ADDENDUM NO1-R1Date: **March 27, 2026**Project No.: **2596**Project: **Alderville Senior's Residence
Renovations**

ALDERVILLE SENIOR'S RESIDENCE RENOVATIONS

Date: March 26, 2026
Project: Alderville Seniors Residence
Renovation
Project No: 25-088
No: ADD-ME01

Date: March 26, 2026
Project: Alderville Seniors Residence
Renovation
Project No: 25-088
No: ADD-ME02

Drawing No:
E301

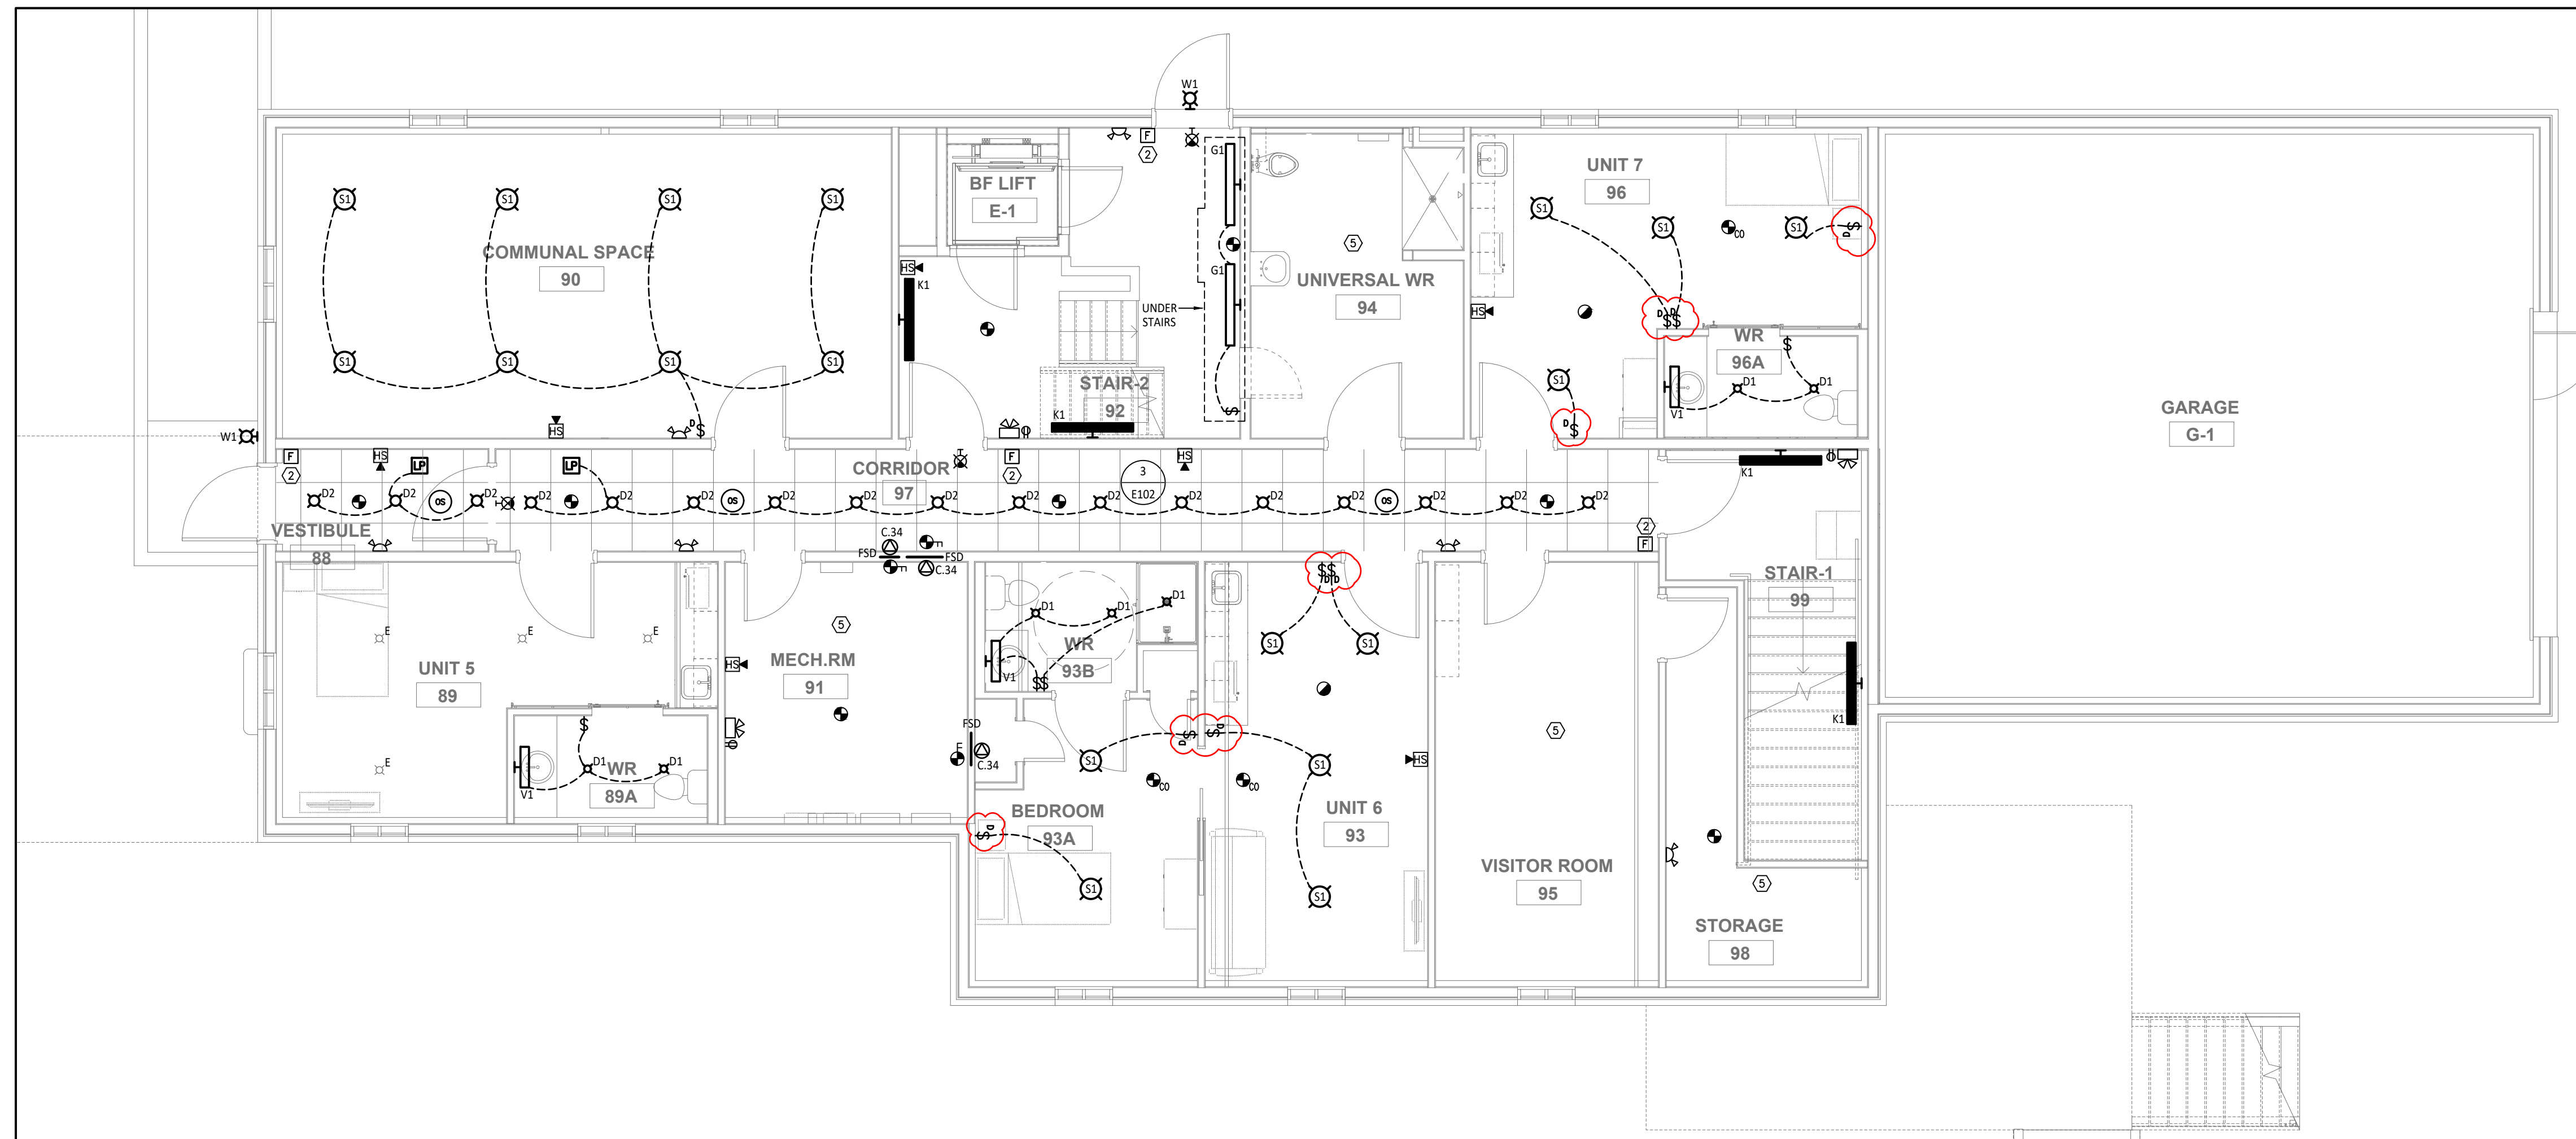
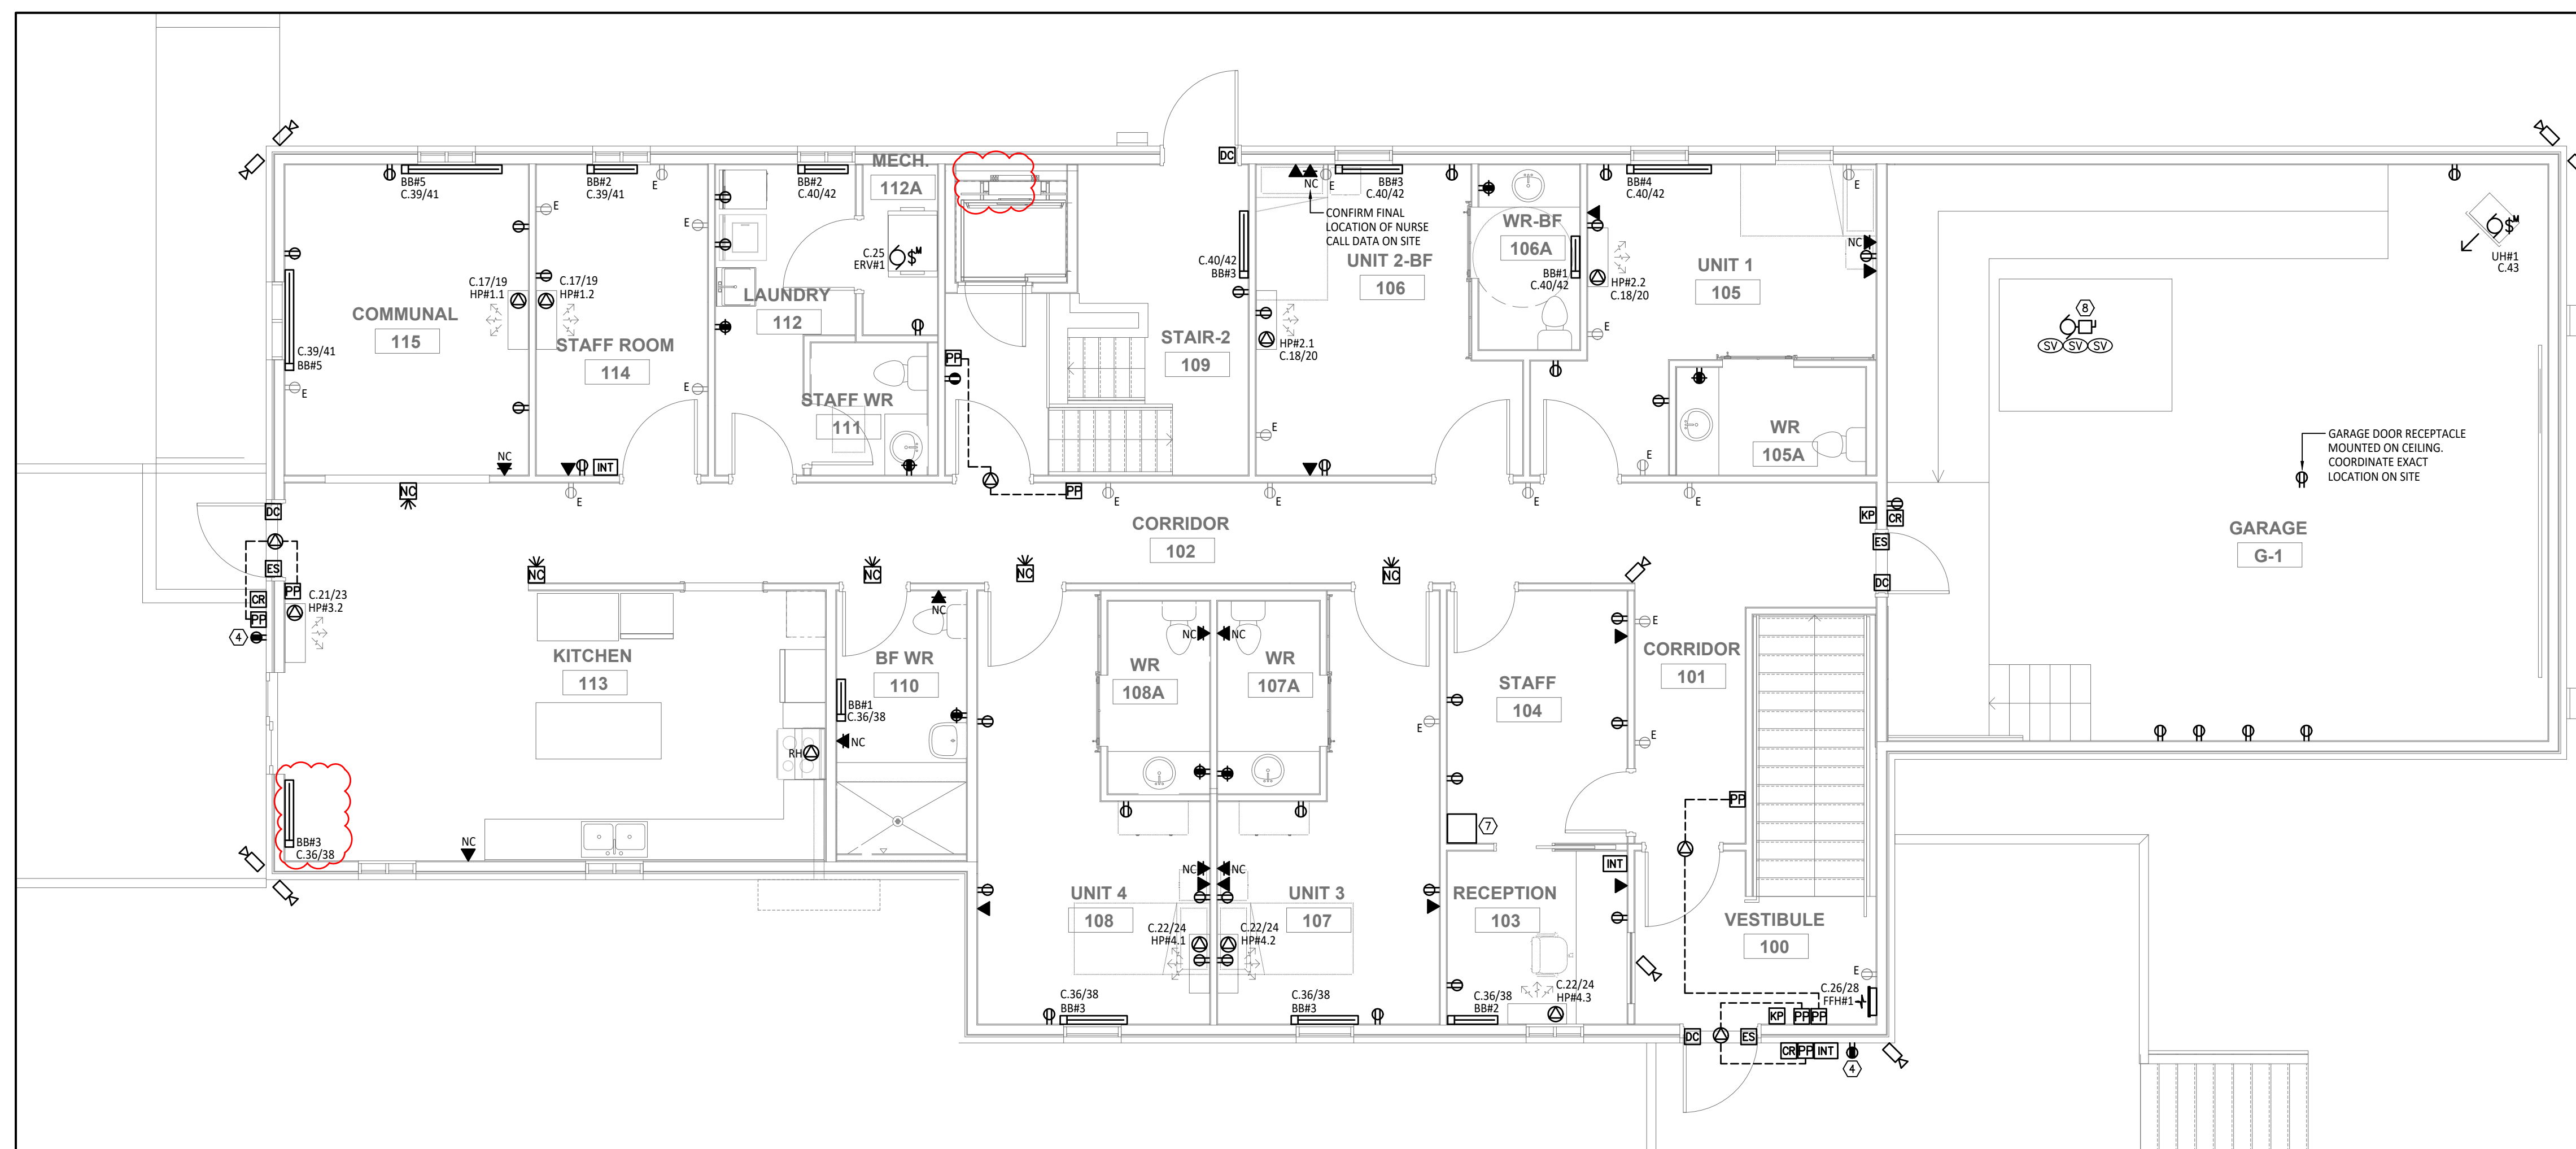
2 REGARDING LIGHTING COORDINATION (DRAWING E301 RE-ISSUED)

.1 Refer to attached drawing for the following revisions:

.1 Revised suit light switches to include for dimming.

.2 Coordination of recessed fixtures in the first-floor corridors.
